Item Name: Crosstube, Low Narrow Fwd, 412CF

Draw Nbr	Revision Nbr
D412-664-145	Rev D (DEO)
DSI9563	<u>68 BGM 13-05-22</u>

DRAWING NO. D412-664-145		TITLE CROSSTUBE ASS'Y (412 LOW-N FWD)		REV. D	DART AEROSPACE LTD ENGINEERING ORDER		D.E.O. NO. D412-664-145-D-1		SHEET NO. SHEET 1 OF 2		SCALE NTS
DRAWN <i>qp</i>		CHECKED <i>Sc</i>		MFG. APPR. <i>E</i>		APPROVED <i>W</i>		DE APPR. <i>H</i>			
DATE 11.05.25		DATE 11.05.31		DATE 11.05.31		DATE 11/25/31		DATE 11.05.31

DRAWING NO. D412-664-145	TITLE CROSSTUBE ASS'Y (412 LOW-N FWD)	REV. D	DART AEROSPACE LTD ENGINEERING ORDER		D.E.O. NO. D412-664-145-D-2	SHEET NO. SHEET 1 OF 1	SCALE NTS
DRAWN 97	CHECKED ASS	MFG. APPR. RS	APPROVED JMP		DE APPR. #		
DATE 11.07.15	DATE 11.07.20	DATE 11.07.21	DATE 11/07/21		DATE 11.07.21

FIGURE 1: SUPPORT INSTALLATION

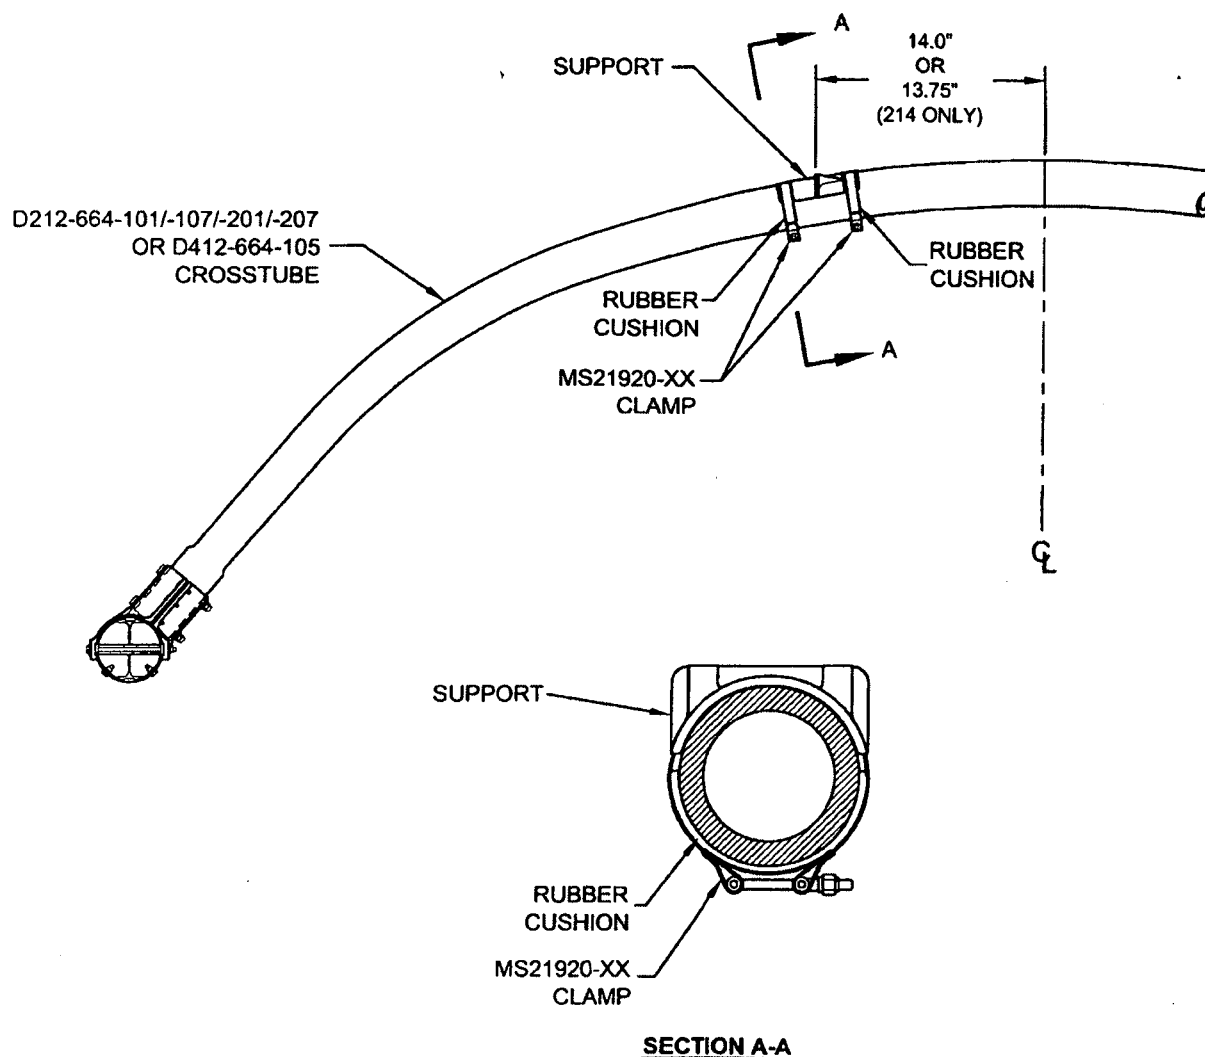
For the crosstubes listed above, section 32.4 of ICA-D212-664 is amended as follows. Use Figure 1 of this service instruction and Figures 32-2 to 32-9 of ICA-D212-664 for further reference. For crosstubes of an earlier change number, it is recommended that if the supports are removed, the supports should be reinstalled using the procedure listed below.

- 32.4.1 Locate the area on the crosstube for installation of support (see Figure 1 of this service instruction). For D212-664-101/-107/-201/-207 and D412-664-105 crosstubes, the outward face of the support tabs should be 14.0" (355mm) from the crosstube center for 204/205/210/412/UH-1 aircraft. For installation on 214B/B-1 aircraft, the outward face of the support tabs should be 13.75" (349mm). Ensure paint finish of crosstube is intact; touch up as required per Chapter 5 (5.3.9) of ICA-D212-664.

- 32.4.5 Apply a 0.04" to 0.07" thick layer of Proseal 890 Class B or AMS-S-8802 Class B sealant underneath applicable support and install support as shown in Figure 1 of this service instruction.

- 32.4.6 Install the clamps opposite to crosstube support as shown in section A-A of Figure 1. Install rubber cushions underneath each clamp around the bottom circumference of the crosstube up to the crosstube centerline. Torque clamps 80-100 in-lb (9.0-11.3 Nm). It is acceptable to use smaller or larger sized MS21920-XX clamps than those listed in ICA-D212-664, ensure that after torquing the clamps per this instruction, the nuts are in safety but not bottomed out

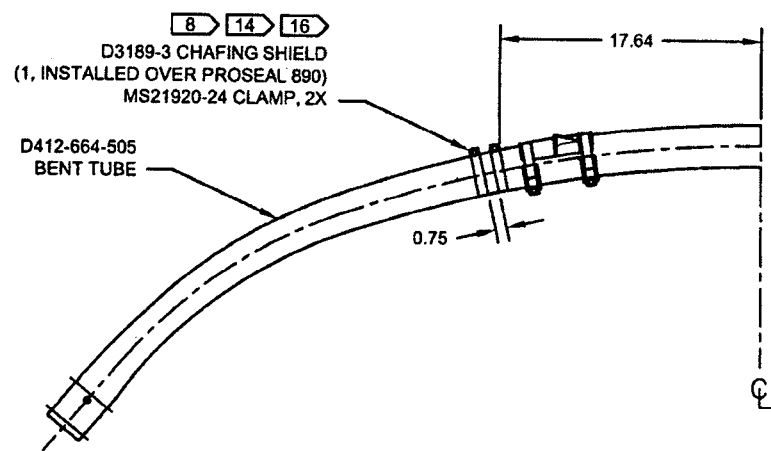
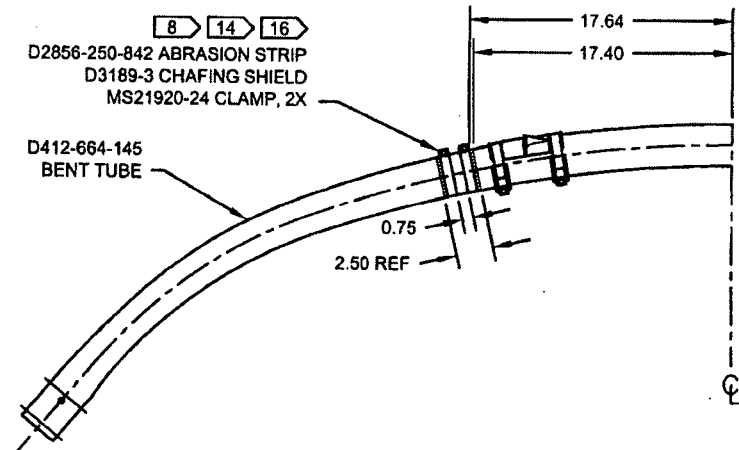
CHANGE:

NOTE 14, SHEET 1 IS AMENDED AS FOLLOWS:

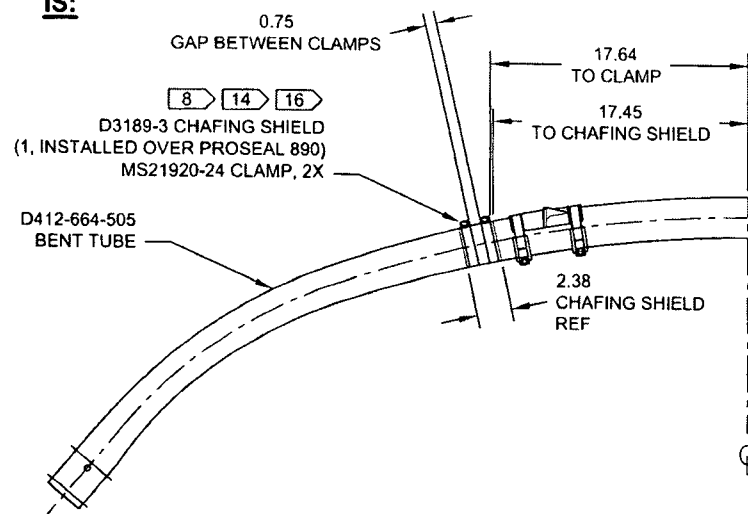
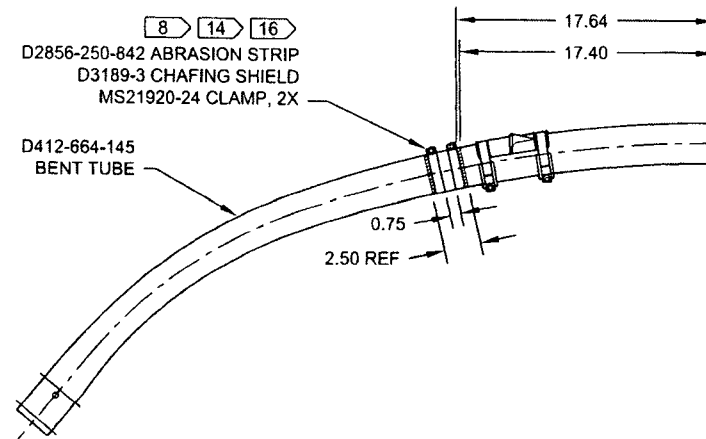
CHANGE:

NOTE 14 AND 16 ON SHEET 1 IS AMENDED AS FOLLOWS:

CRUSHING OF D412-644-105

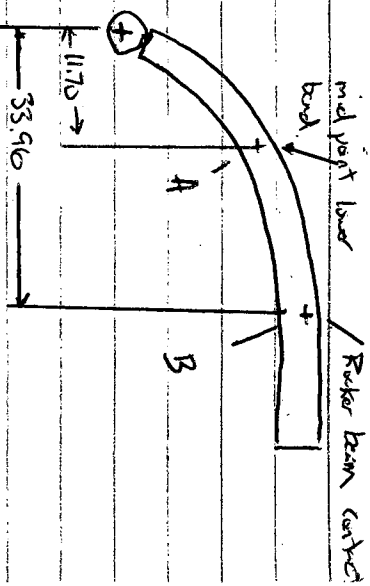
Point A: $\omega = 2.511$ $\text{ID} = 2.125$
 ~~$\text{ID} = 1.886$~~
